Product Change Notice

PCN#: EE-PCN18009

Increase pad dimension size of the recommended pad layout.

Current Pad Layout

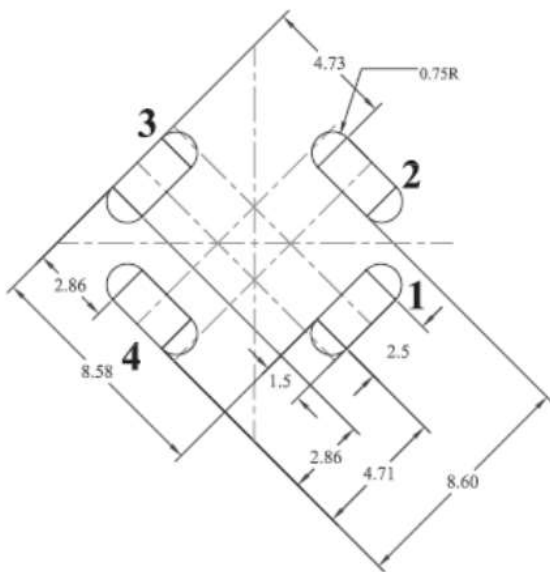
To improve accuracy in placing component on the pad area.
